<b>Project</b>	Steamboat Base Village Redevelopment	<b>Date</b>	06/21/2021
<b>Project Location</b>	Steamboat, Colorado	<b>Architect's Project Number</b>	03.7835.000
<b>Owner/Client</b>	Alterra Mountain Company / East West Partners	<b>File</b>	6BL <b>This is page</b> 1 of 3
<b>To</b>	Saunders Construction Inc.	<b>Attention</b>	Bryan Sculthorpe
<b>Address</b>	86 Inverness Place North		
<b>City</b>	Englewood	<b>State</b>	CO <b>Zip Code</b> 80112
<b>Delivered via:</b>	<input type="checkbox"/> Messenger	<input type="checkbox"/> Hand carried	<input type="checkbox"/> Facsimile
	<input type="checkbox"/> Express	<input type="checkbox"/> Pick-up	<input type="checkbox"/> E-mail Address
	<input type="checkbox"/> Mail	<input type="checkbox"/> UPS	<input checked="" type="checkbox"/> Website Address BIM360

<b>Attachments</b>	BP3 - BULLETIN 01		
<b>Requested by</b>	<input checked="" type="checkbox"/> Architect	<input type="checkbox"/> Owner	<input type="checkbox"/> Contractor
	<input type="checkbox"/> Other (specify): _____		
<b>Issued by Gensler by</b>	Jacob Apple	<b>Date Signed</b>	06/18/2021
<b>Issued by Owner by</b>		<b>Date Signed</b>	
	<input type="checkbox"/> Required; Please return signed

**COMPOSITE SECTIONS**  
**1A-L7-08**

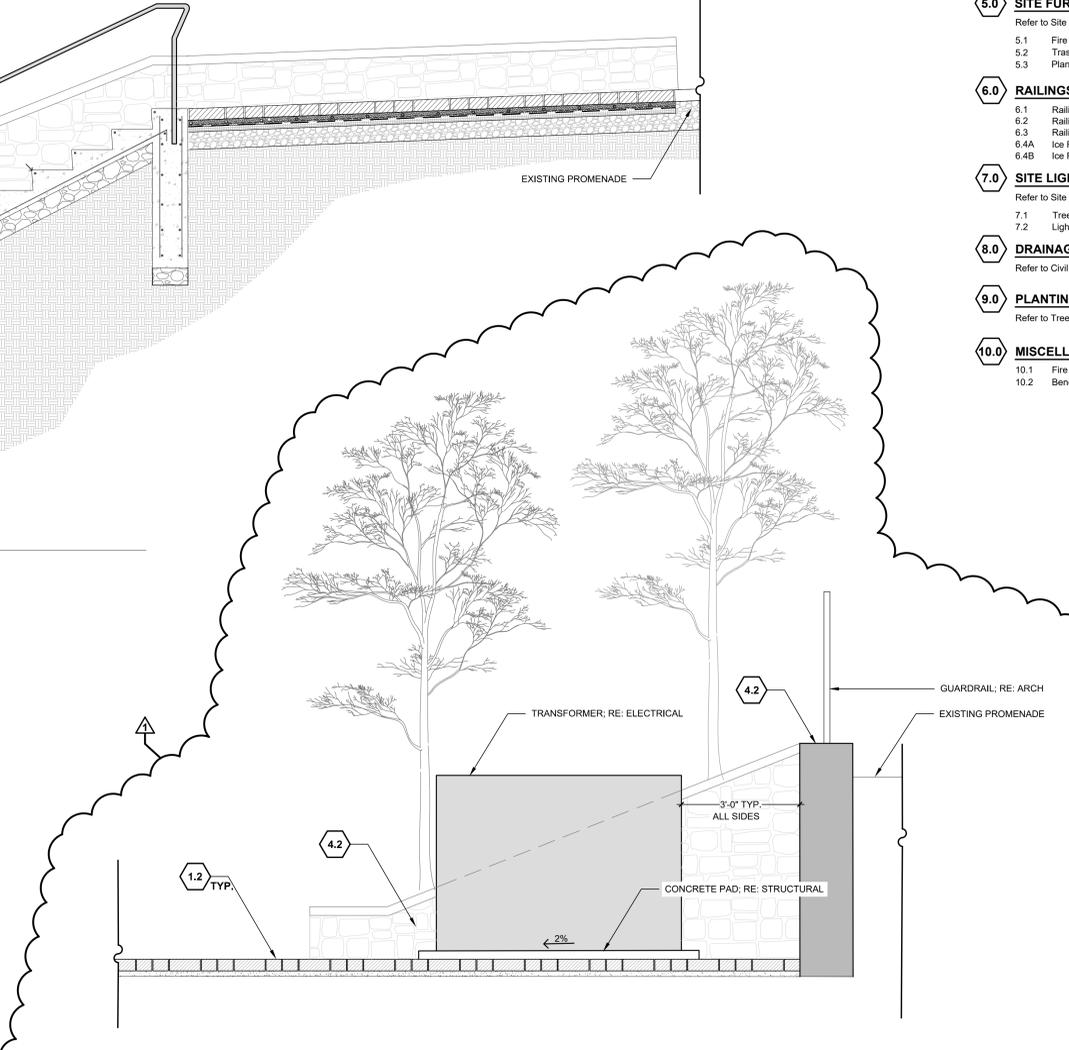
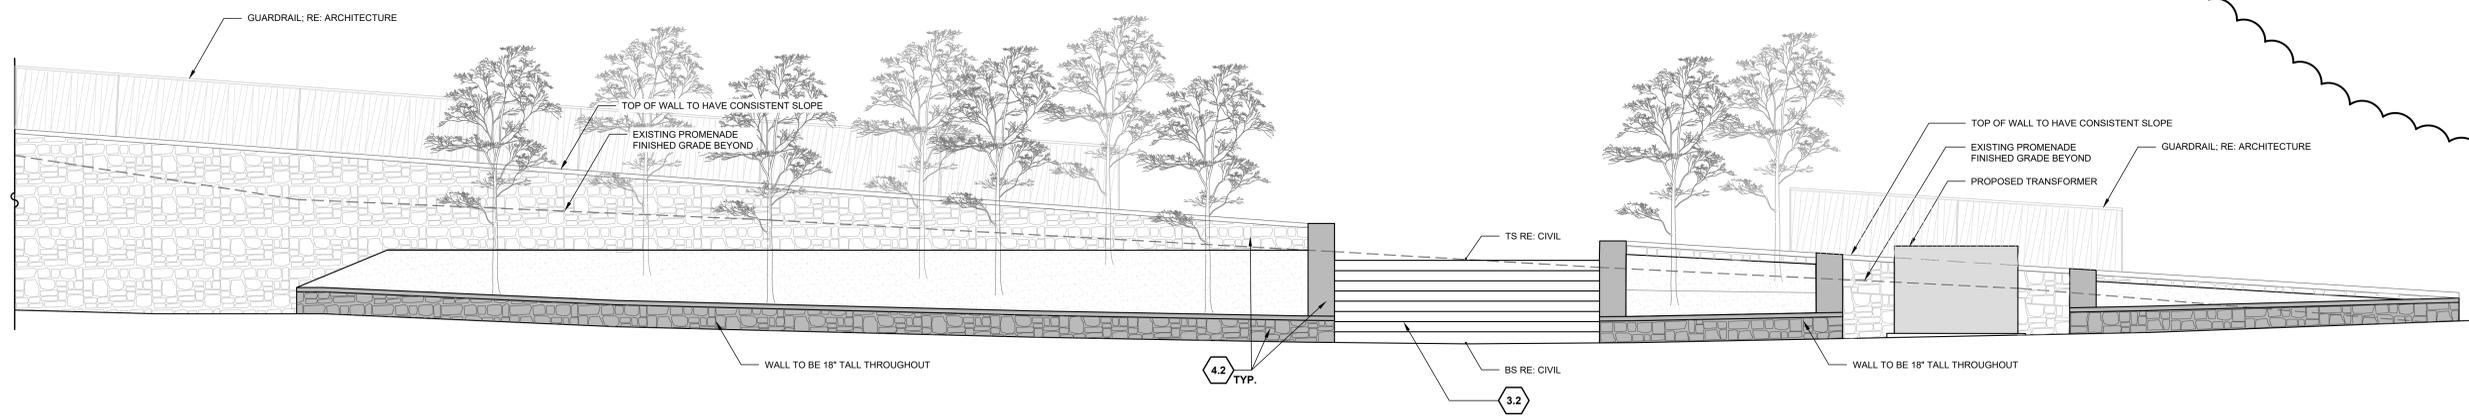
- a. Elevation 2 added and elevation 3 revised to show relationship of southern promenade walls and transformer.
6. 1A-L8-02 Planting Plan
  - a. Trees removed from southern portion of promenade planter, shrubs and groundcovers redistributed to accommodate new wall layout.

**SITE FURNISHINGS PLAN**

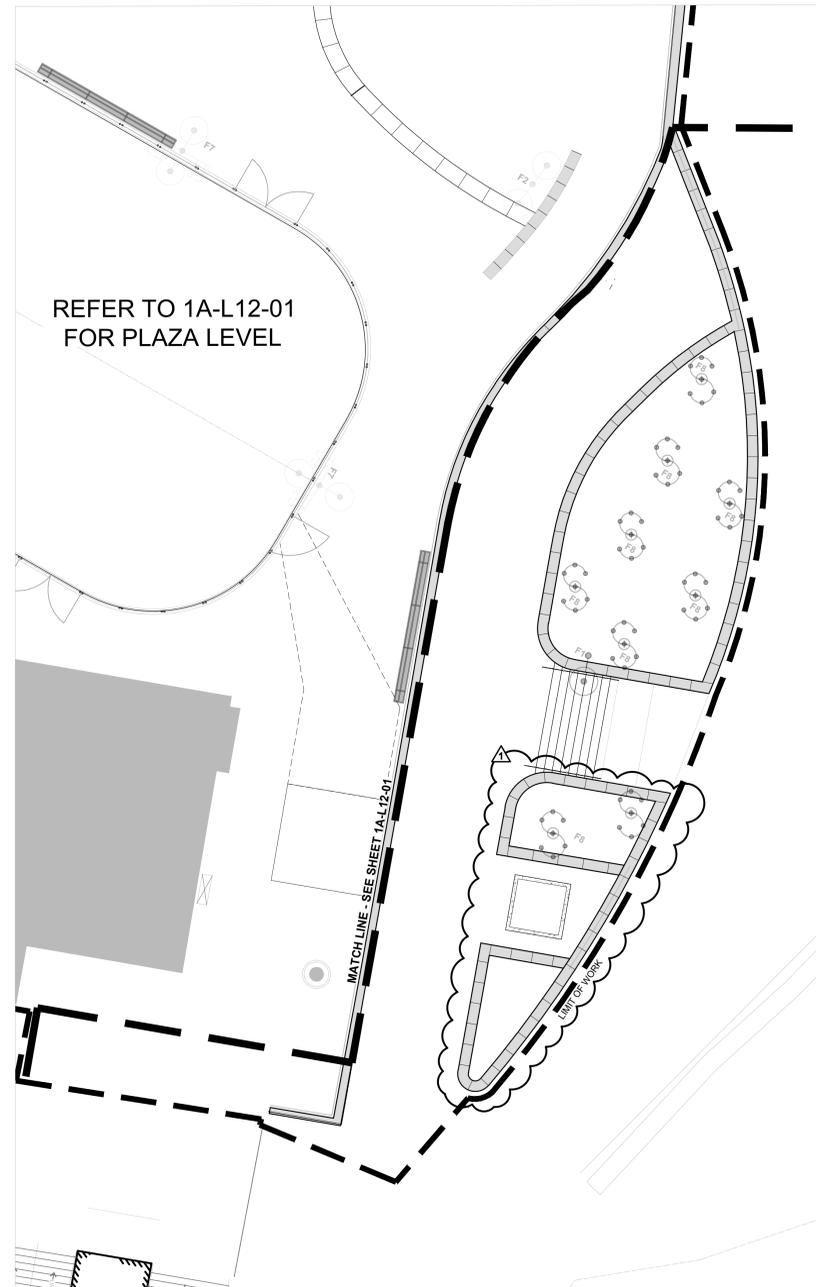
7. 1A-L12-02 Site Furnishings Plan
  - a. Southern promenade planter walls reconfigured to accommodate transformer.

PROMENADE - ARCHITECTURAL SITE PLAN

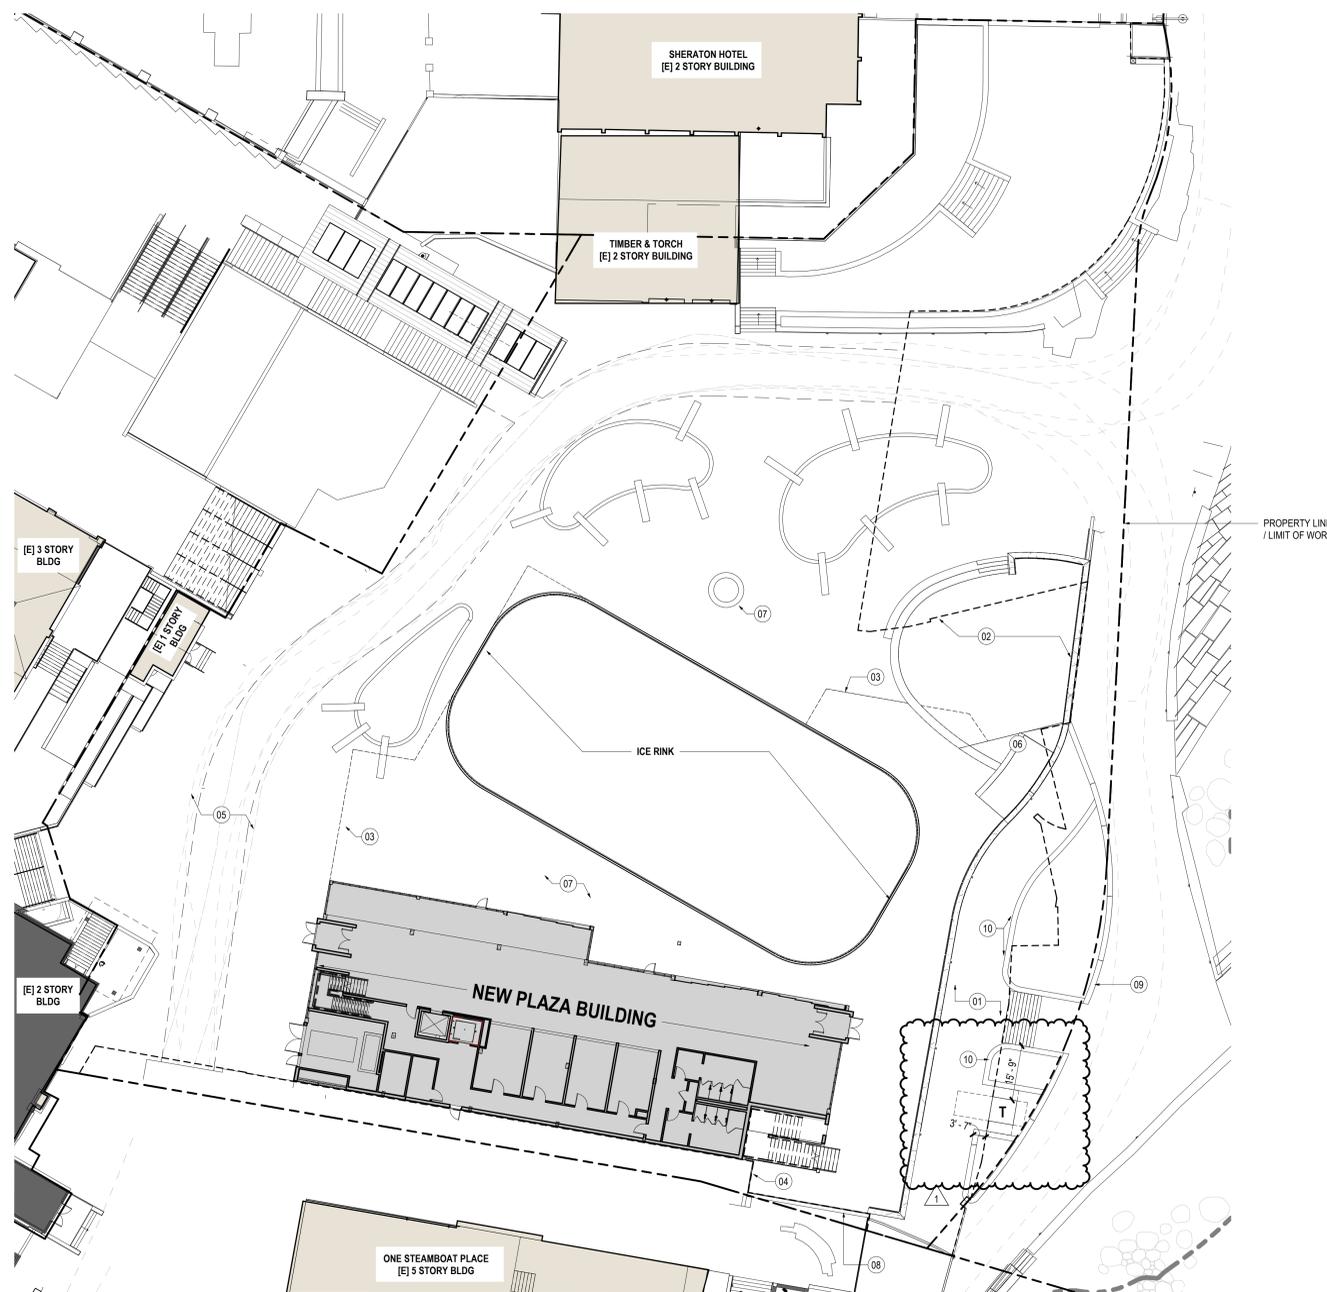
1. 1A-A1.100 – PROMENADE - ARCHITECTURAL SITE PLAN - LOWER LEVEL B1
  - a. ARCHITECTURAL SITE PLAN
    - i. Relocated transformer shown with revised site walls

Description  
**PROMENADE - ELECTRICAL UNDERGROUND CONDUIT PLAN**

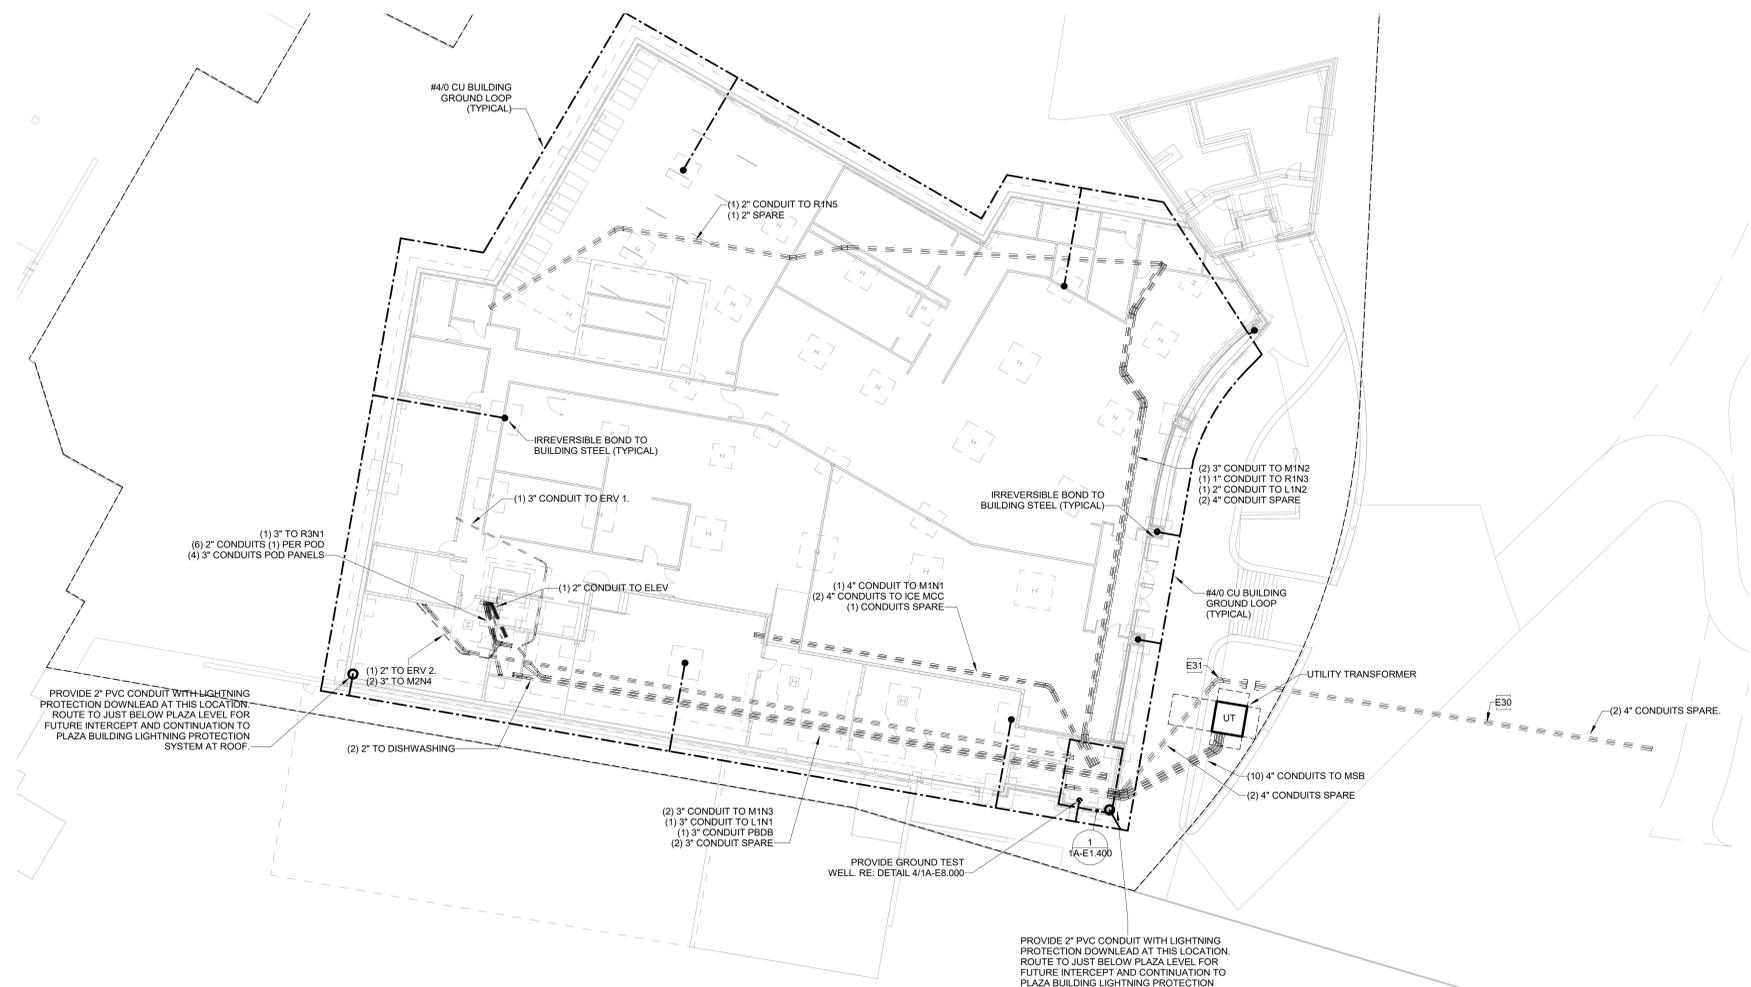
1. Sheet 1A-E0.001
  - a. Removed secondary connection cabinet for secondary feed into building to align with approved VE.
  - b. Modified feeder quantity, size, material, and length for secondary conduits coming into building to align with approved VE.
  - c. Modified short circuit table values based on approved VE of secondary feeder.
2. Sheet 1A-E1.000
  - a. Modified site lighting at SE corner of site to align with request from utility for removal of trees on south side of transformer.
  - b. Modified S1 lighting on Promenade lower façade per recent development plan coordination.
3. Sheet 1A-E1.100U
  - a. Added (2) spare conduits into building from East side of Burgess Creek per request from owner.
  - b. Modified transformer location to align with approved VE.
  - c. Modified utility transformer secondary conduit routing into building.
